685 PACIFIC BOULEVARD - SOUTH TOWER (COMPLETE APPLICATION)
DE416437 - ZONE CD-1

EXECUTIVE SUMMARY

DEVELOPMENT PERMIT STAFF COMMITTEE RECOMMENDATION: APPROVE

A0 102

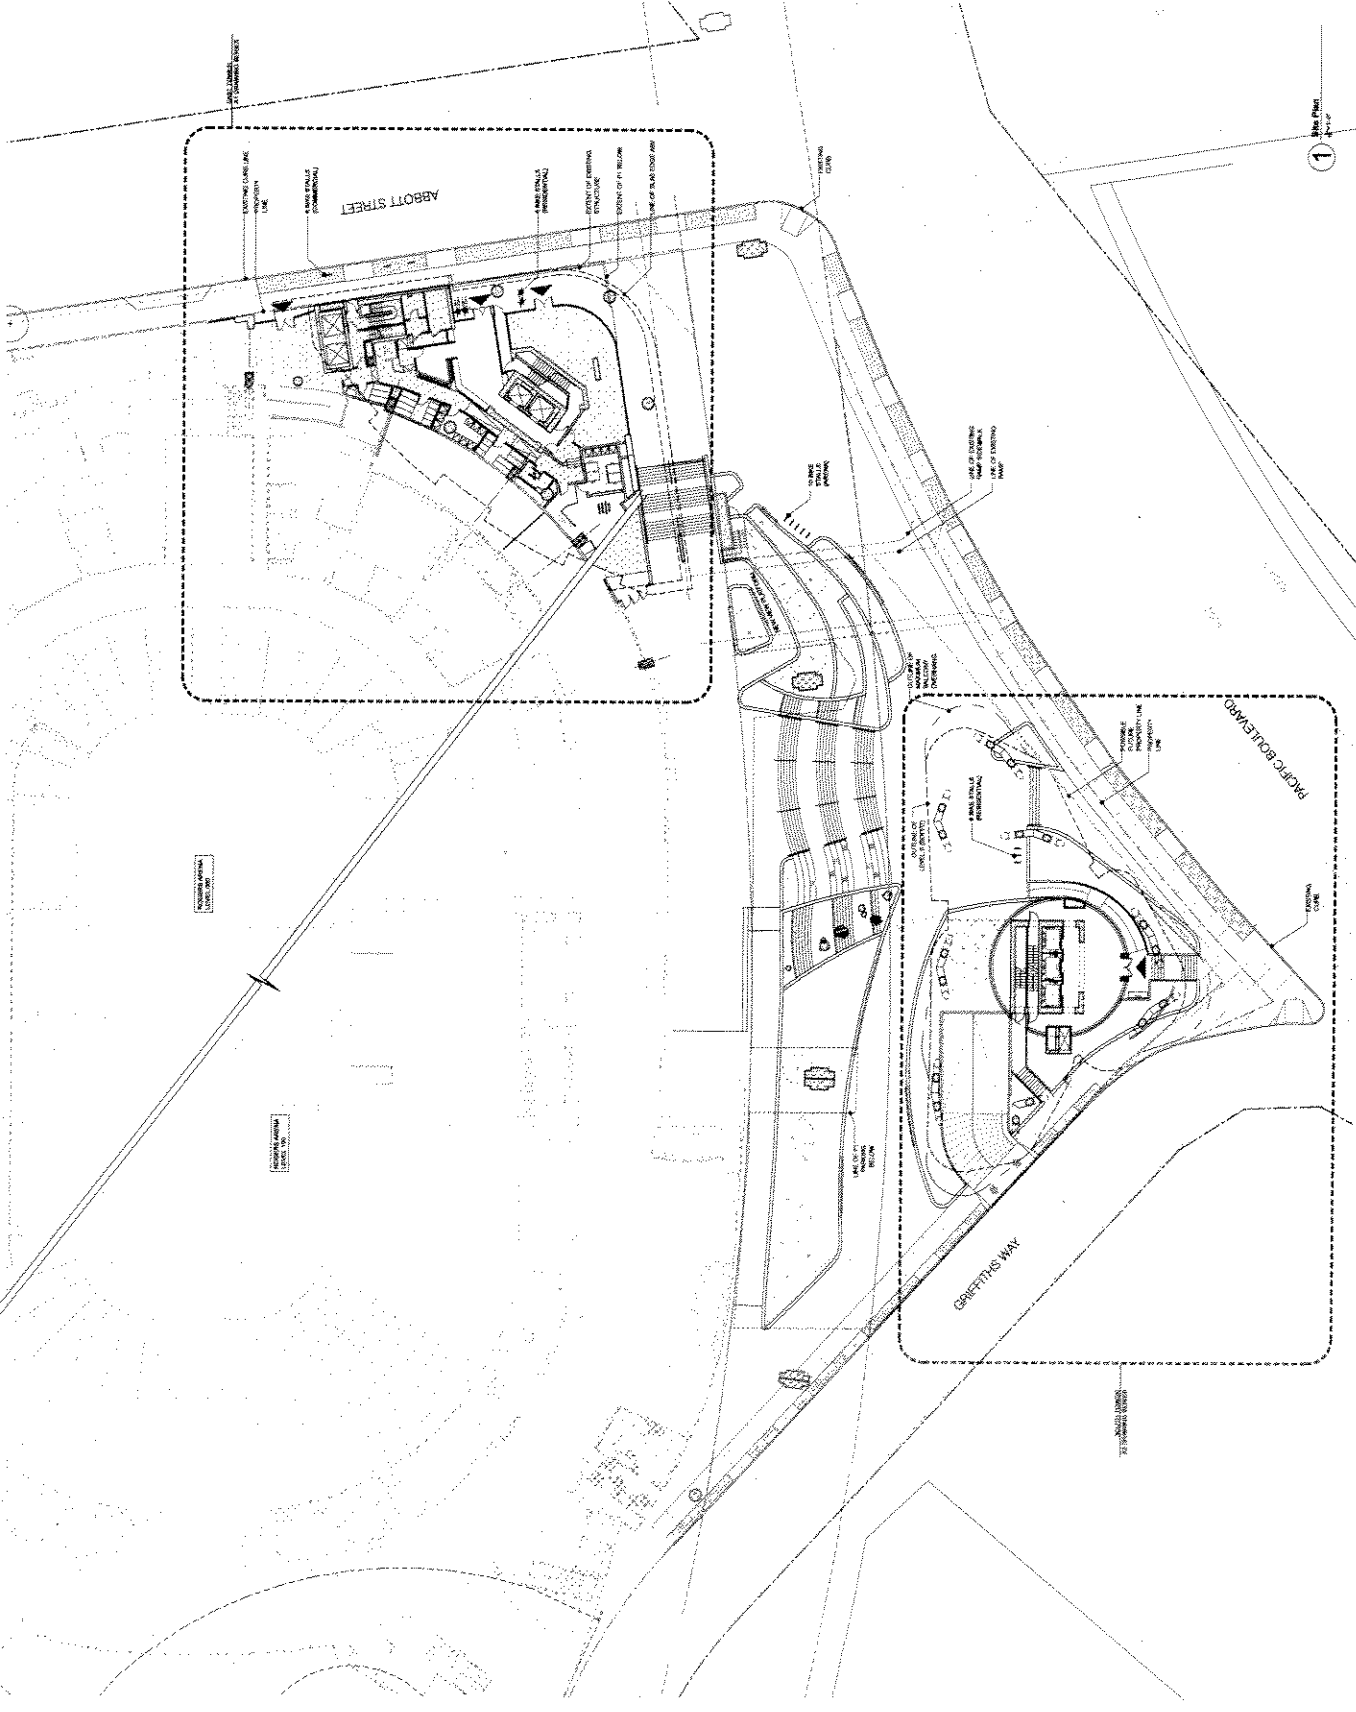
Note to Applicant: Drawing LDP 1.02 shows the future alignment of Griffiths Way which would narrow the sidewalk between the curb ramp and the planter wall to 2.0 m which is a less than desirable pedestrian space allotment at the intersection.

Note to Applicant: Plans A0 102 and A0 103 show the "outline of maximum balcony overhang" over portions of the site to be dedicated for road along Griffiths Way.

1.4 design development to the planter wall and front entrance of the South Tower in its future configuration at the corner of Pacific Boulevard and Georgia Street to achieve a minimum width of 5.5 m sidewalk;

1 Level P1

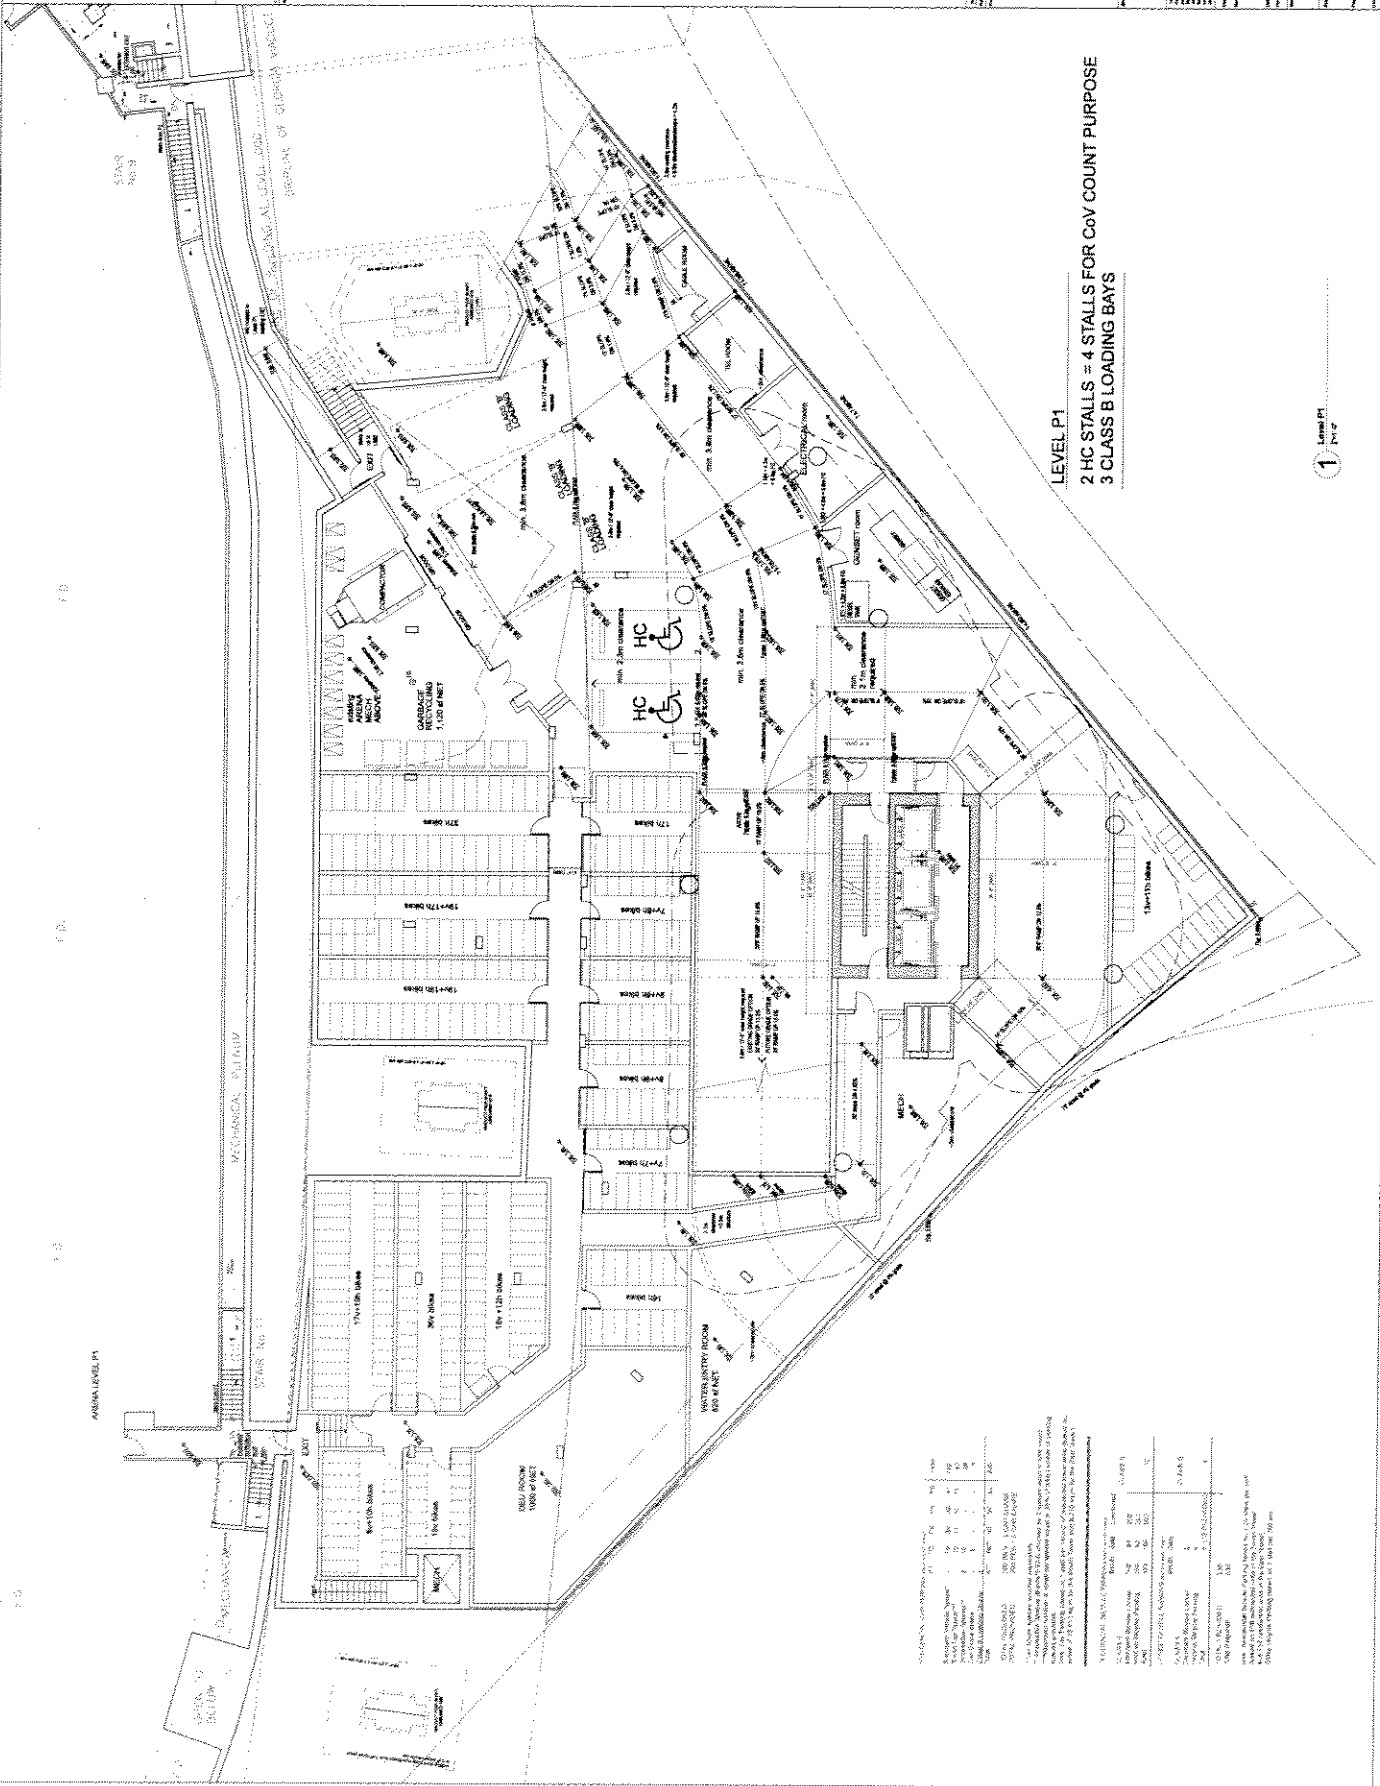
Note to Applicant: Columns are encroaching from the bike rooms on P1 onto the ramps on drawing A2 205.

Note to Applicant: Ensure that the 12.5 ft. (3.8 m) of vertical clearance is still provided with any future change in the ramp slope and design. Remove notation on drawing A2 205 indicated approximately 9.8 ft. (3 m) of clearance is being provided. Consider installing a bang bar at the top of the ramp to limit trucks to the 3.8 m of vertical clearance.

- A.2.16 provision of a section drawing along the centreline of the ramp and maneuvering aisle showing the minimum 12.5 ft. (3.8 m) of vertical clearance from the street to the three Class B loading spaces;
